Lomas Blvd. Missing Sidewalk

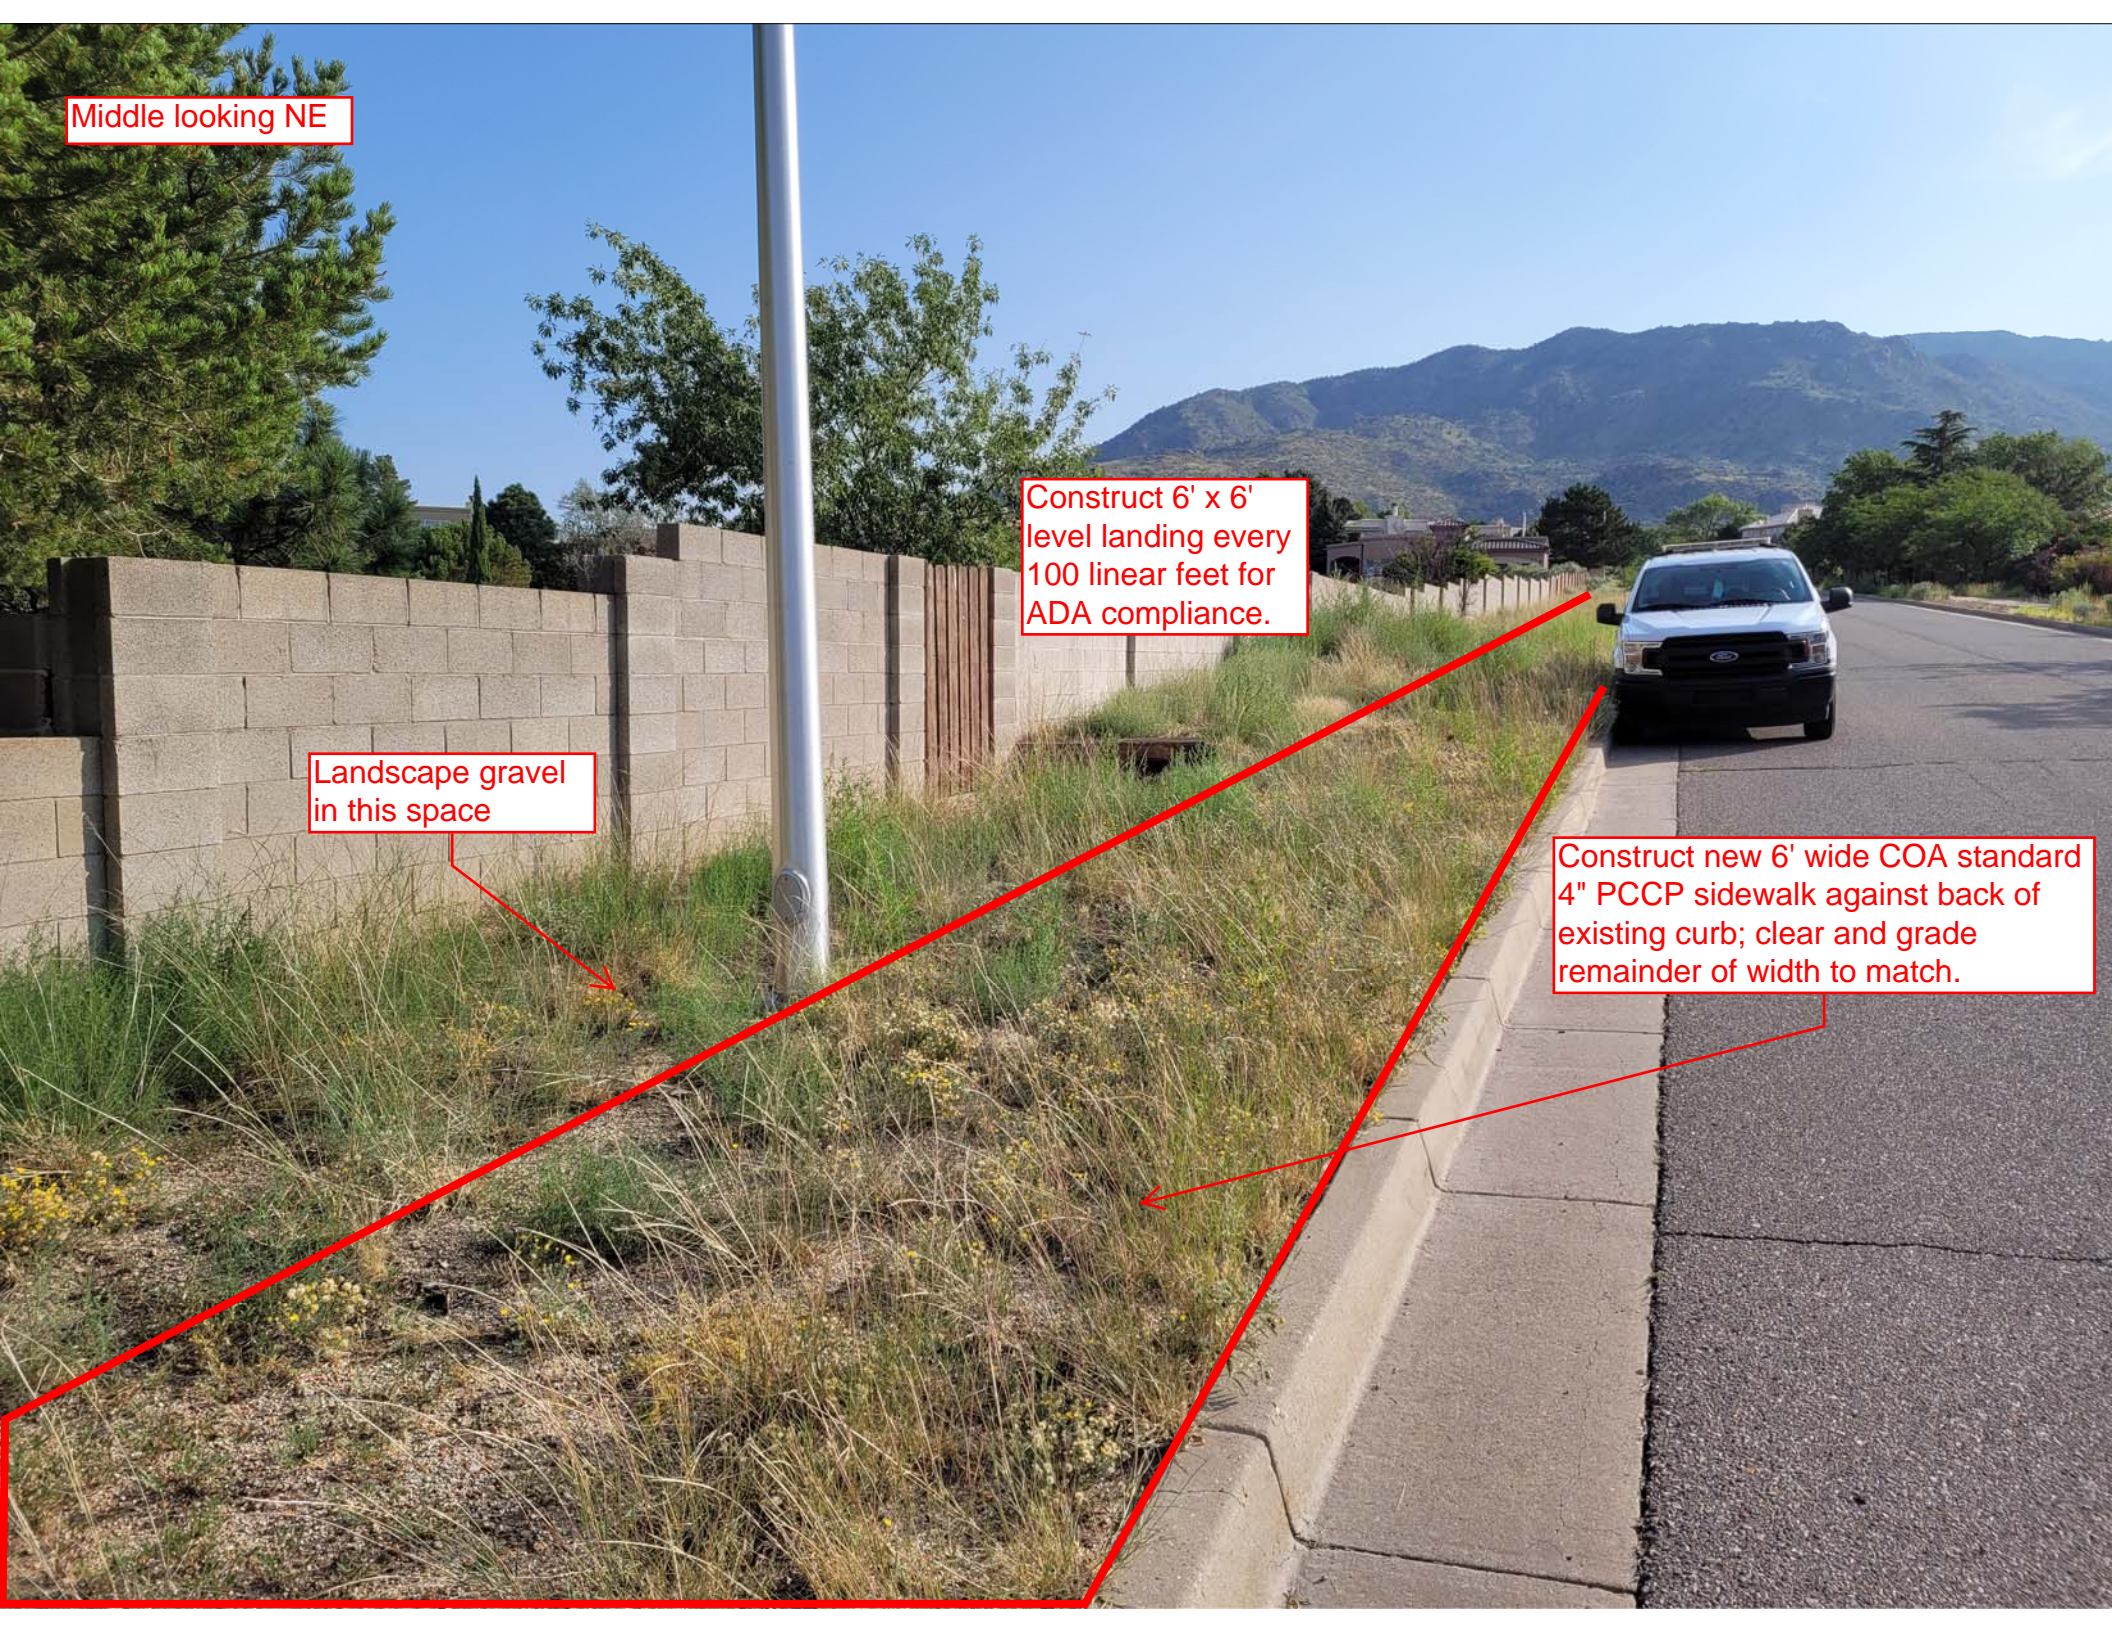
Tie to existing  
sidewalk here.

Construct 6' x 6' level landing every 100 linear feet for ADA compliance.

Landscape gravel in this space

Construct new 6' wide COA standard 4" PCCP sidewalk against back of existing curb; clear and grade remainder of width to match.

Begin new  
sidewalk here.

Remove and  
replace curb ramp  
and fillet.

Please provide a separate cost to install three benches similar in color and style to the existing benches at Embudo Hills Park. Benches shall be mounted on a level 4" concrete pad between sidewalk and existing CMU wall, locations TBD in the field.
